Attachment D
Comments Received

Brightline West Cajon Pass High-Speed Rail Project Environmental Assessment

Brightline West Cajon Pass Environmental Assessment -Final

FIGURE 1: EXISTING AND PROPOSED HIGHWAY AND TRACK SECTIONS

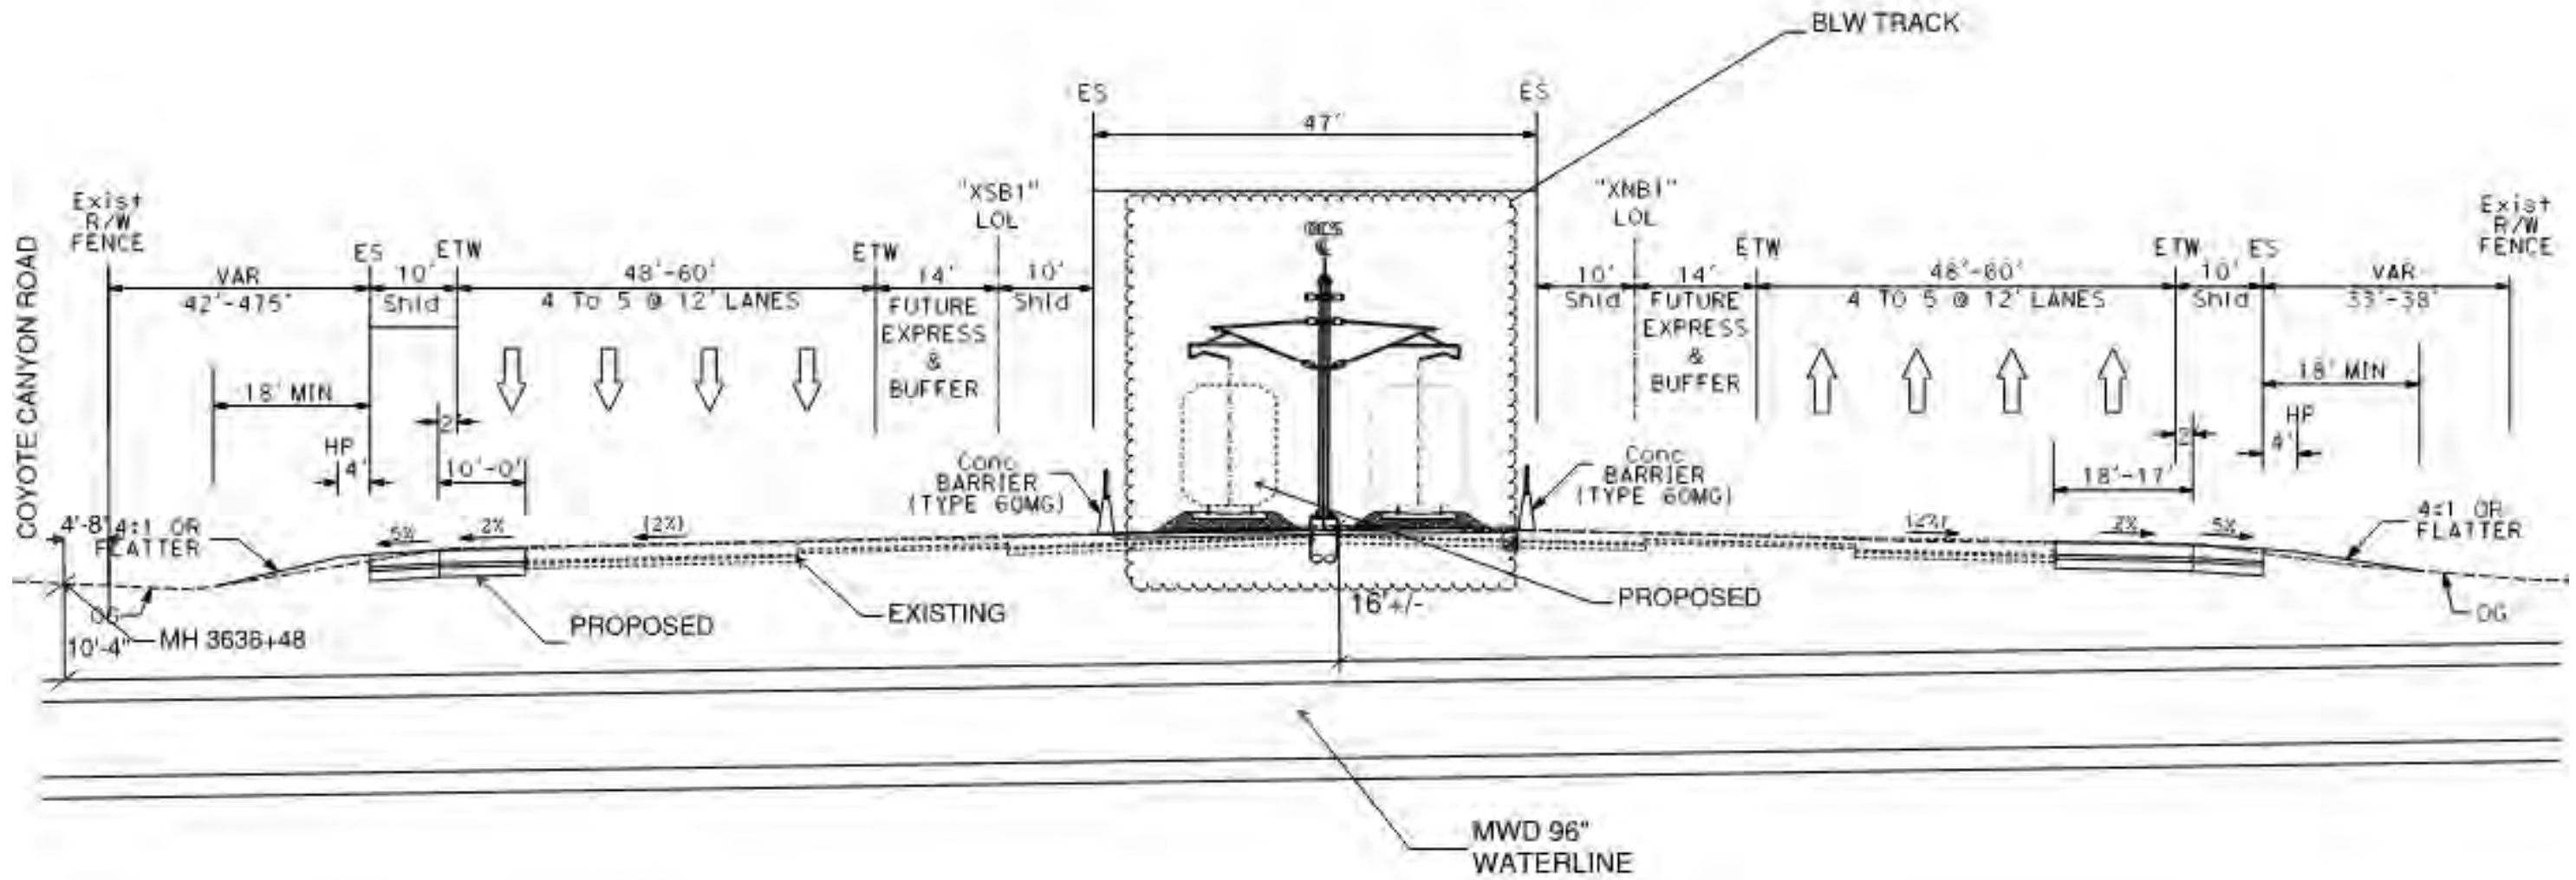
2. Metropolitan has concerns that the specified loading standard (Cooper E-70) does not fully encompass the high-speed rail's impact to our facilities. Please provide the following:

3. Provide at least three experimental/case study historical data from analysis of similar high speed rail crossings with three-component ground acceleration at multiple distances to 100 feet perpendicular from the railroad. These examples should include soil properties, and have similar rail properties (loading and maximum speed) as the proposed railway.

4. Provide a site-specific geotechnical report which should include the shear wave velocity profile and shear strength of the soil.
5. Provide a 3D analysis of Metropolitan's pipeline. Per Metropolitan's Geotechnical Guidelines, the three-dimensional alignment of the pipeline should be considered in calculating the vertical and lateral deformations and in computing the fiber, hoops, and

Figure 1 Showing Alignments of Rialto Pipeline/Proposed Railroad Track and Seismograph Locations

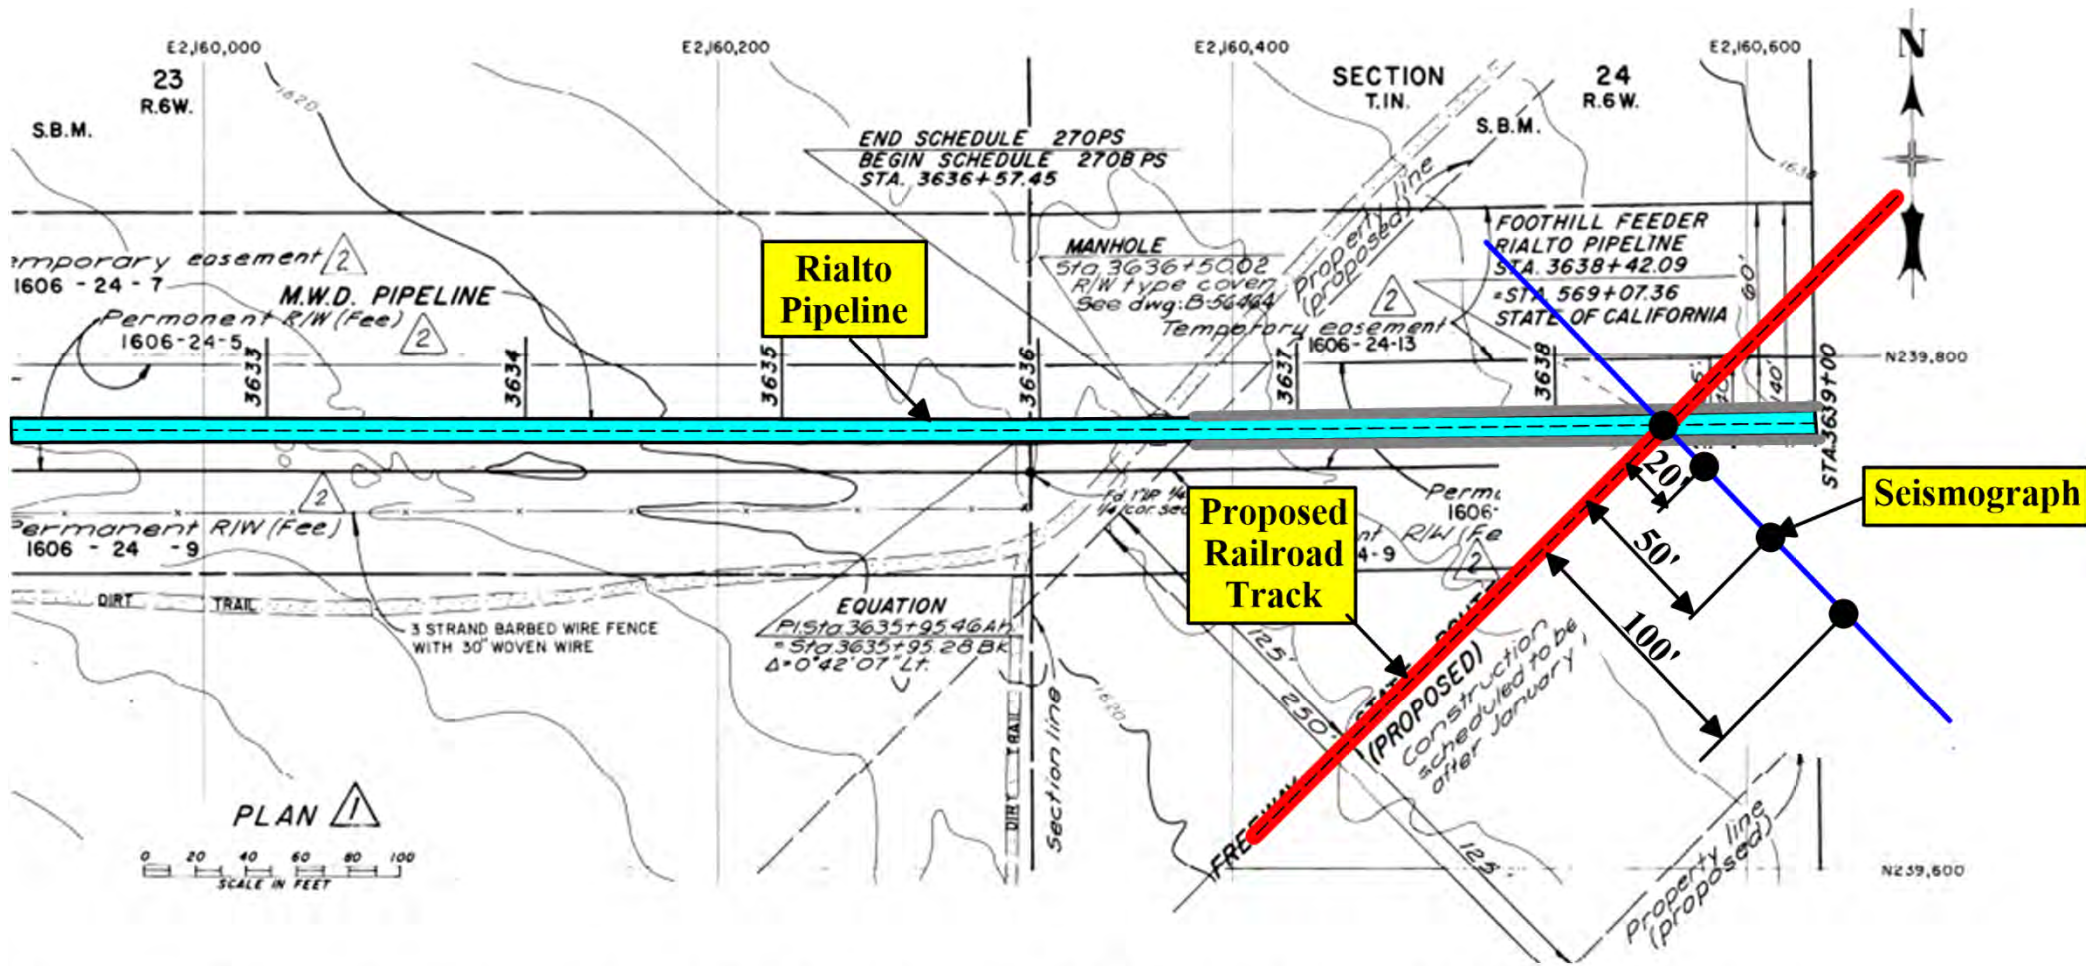
Figure 1 shows the plan view of the track of the proposed High-Speed Train (HSP) and the alignment of the existing Rialto pipeline. Based on the figure, the HST is obliquely overcrossing the pipeline while inducing not only cyclic vertical and horizontal displacements but also twisting the affected reach of the pipeline alignment clockwise and counterclockwise in the horizontal plane. The cyclic deformations of the pipeline could be evaluated if a few seismographs were installed on the ground surface for example at the track, 20, 50, and 100 feet away from the track, as shown schematically in Figure 1, and recorded the ground motions while the HST crossing the seismographs. The measured ground acceleration/velocity/displacement time histories could be used to empirically estimate the pipeline deformations due to the HST overcrossing.

1. Available experimental studies/case histories providing the three components (two horizontal and one vertical) of the ground accelerations/velocity/displacement time histories at and adjacent to the HST track somewhere (e.g., California, Europe, Japan, etc.) having the same foundation conditions and using the same Siemens NOVO train with a maximum axle load of 38 kips with speed in the range of 125 to 155 miles per hour. The alignment of the array of seismographs, as presented in Figure 1, should be normal to the track in order to show the lateral attenuation of the Rayleigh waves with distance from the HST track. Note that the two horizontal components of each seismographs should be normal and parallel to the track. The measured ground acceleration/velocity/displacement time histories can be used to estimate the pipeline cyclic deformations and twisting due to the HST overcrossing.
